**REQUEST FOR TENDER No. 26-023**

**River’s Edge Water Quality Improvement**

**Addendum 4**

**Issued: July 3, 2026**

PW6 - 5'

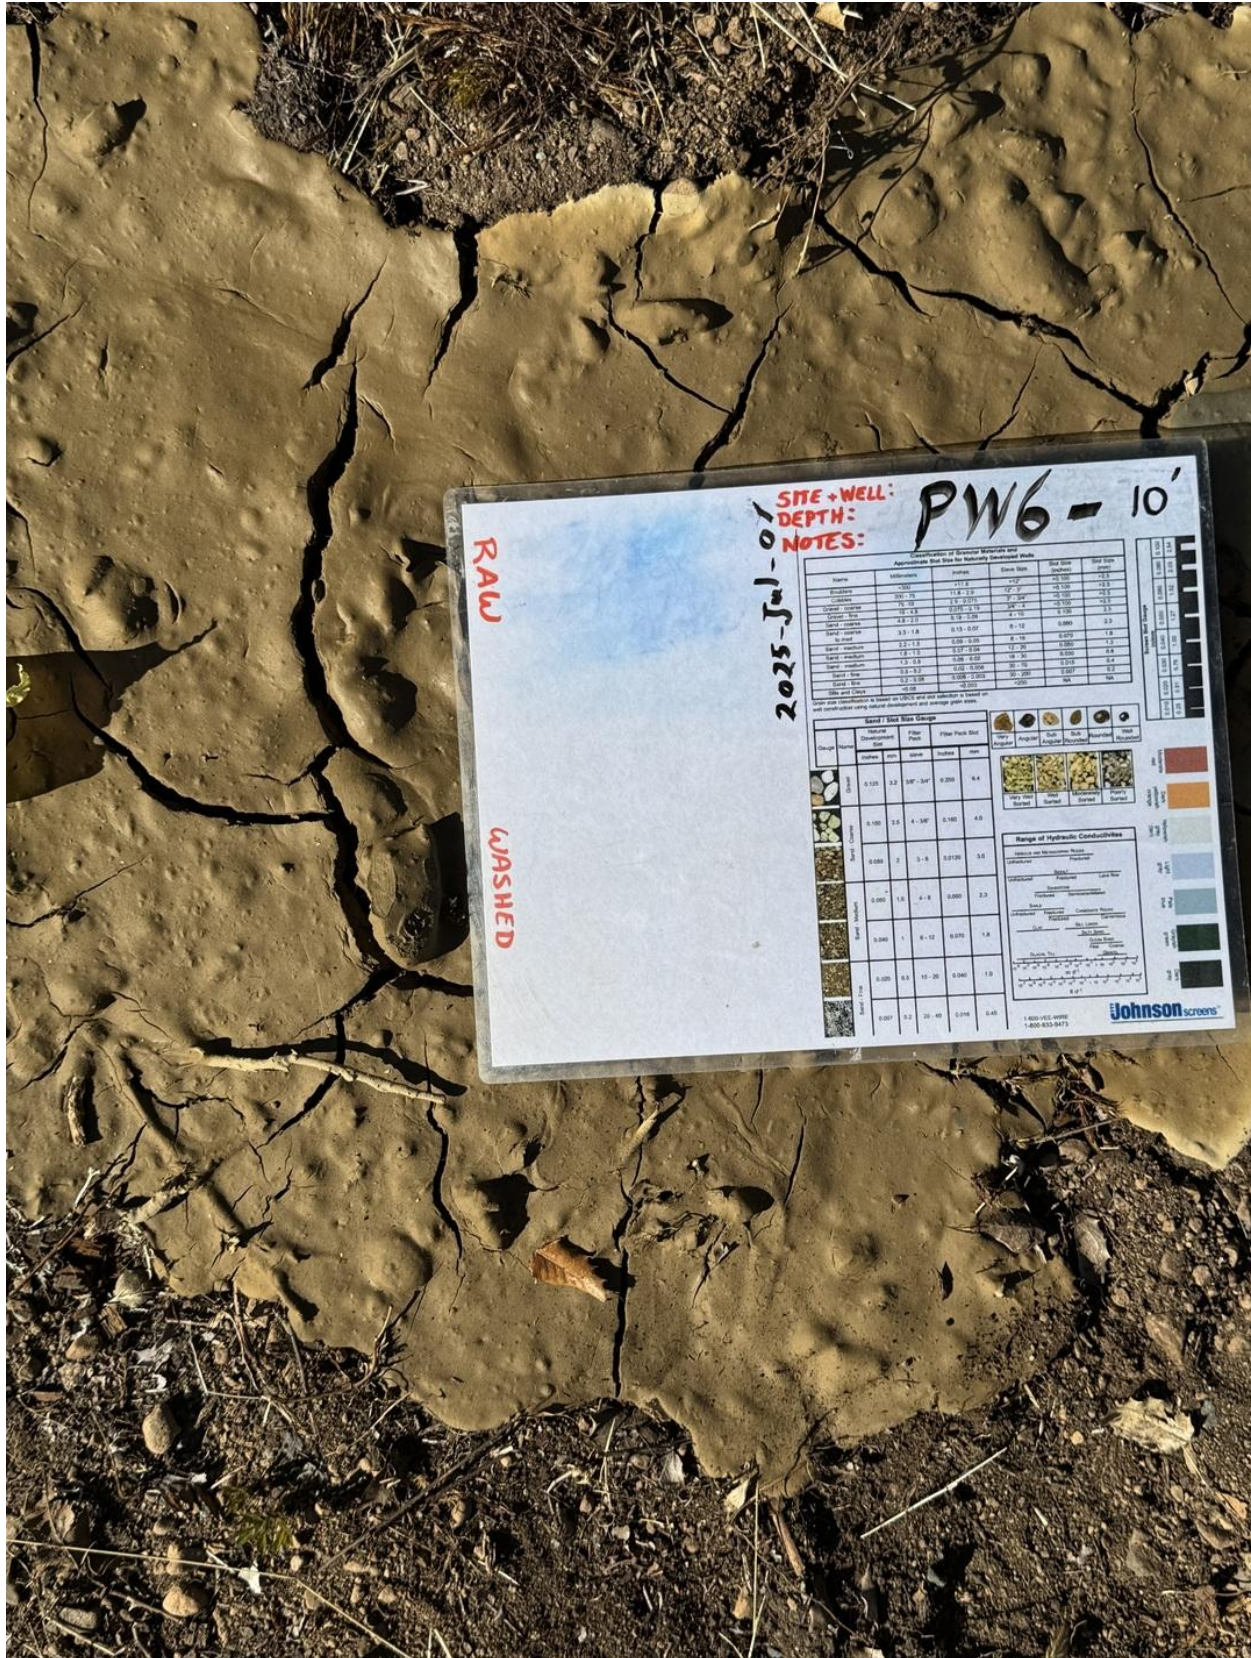
Refer to the attached photos of the soil conditions during drilling of PW6 & PW7 at 5', 10', and 15' below ground.
